## **Addendum 6: United Nations Global Technical Regulation No. 6**

**United Nations Global Technical Regulation on Safety glazing materials for motor vehicles and motor vehicle equipment**

### **Amendment 3 – Appendix 1**

## Request for authorization to develop an amendment to UN Global Technical Regulation No. 6 (Safety Glazing)

Figure 4

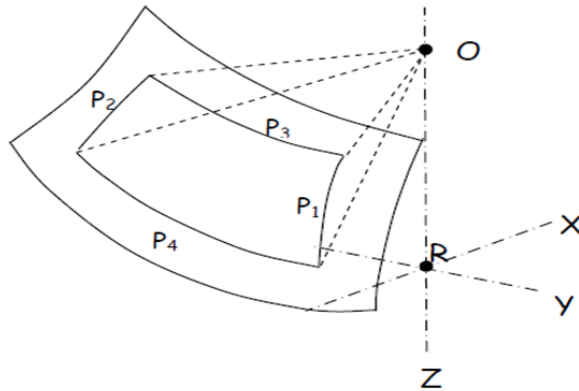
- (v) Para. 7.1.3.3.2. Zone I is the zone determined by the intersection of the windscreen with the four planes defined below:

In addition, opaque obscuration can be exempted in Zone I. It is the limited areas where it is intended that a sensing device, e.g. a rain-drop detector, rear view mirror or autonomous vehicle sensors, will be bonded to the inner side of the windscreen. The opaque obscuration where such devices may be applied is defined in paragraph 7.1.3.2.4.(Figure 2(a) or Figure 2(b)) of this annex.

P1 a vertical plane passing through O and forming an angle of 15° to the left of the median longitudinal plane of the vehicle;

P2 a vertical plane symmetrical to P1 about the median longitudinal plane of the vehicle.

If this is not possible (in the absence of a symmetrical median longitudinal plane, for instance) P2 shall be the plane symmetrical to P1 about the longitudinal plane of the vehicle passing through point O.

P3 a plane passing through a transverse horizontal line containing O and forming an angle of  $10^\circ$  above the horizontal plane;

P4 a plane passing through a transverse horizontal line containing O and forming an angle of  $8^\circ$  below the horizontal plane;

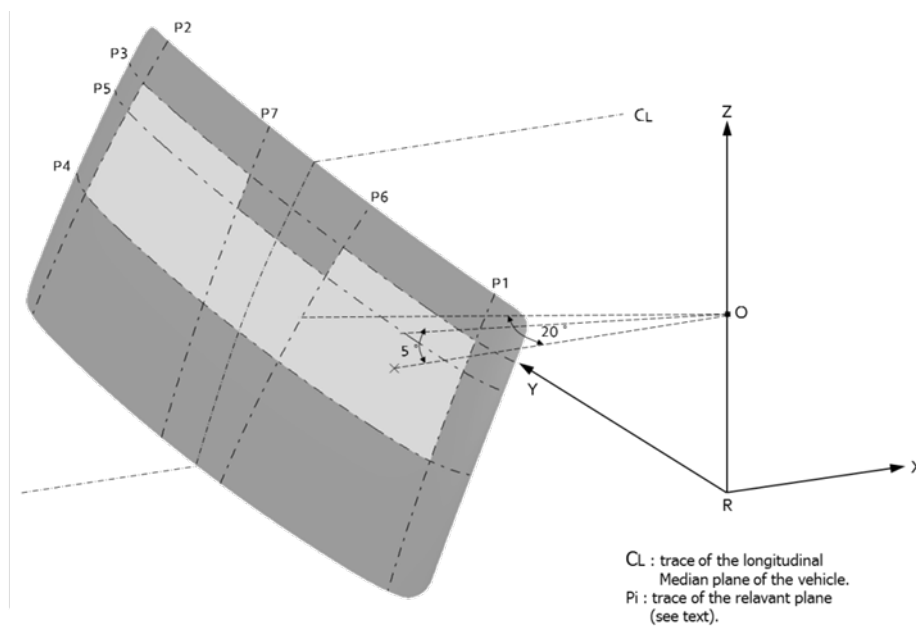
7. Various safety and convenience options (Lane Departure Warning Systems (LDWS), Autonomous sensors, etc.) for trucks are being installed or under development. If these options are fitted on the underside dashboard-top of the windshield glass, it may limit the driver's direct front of vision.

8. For the optimization of installation, the above options may be integrated with the interior mirror. However, it is difficult for some models to install the interior mirror, since Zone I may be intruded. Therefore, the opaque obscuration which can be used for installation of the above safety and convenience options must be permitted additionally. For this reason, some new planes such as P5, P6, and P7 shall be added. On the other hand, the new opaque obscuration for Category 1-2 and 2 Vehicles has to be equal level with the one for Category 1-1 vehicles using the "V" points in order not to violate safety.

Determination of the opaque obscuration by defining planes P5, P6, and P7
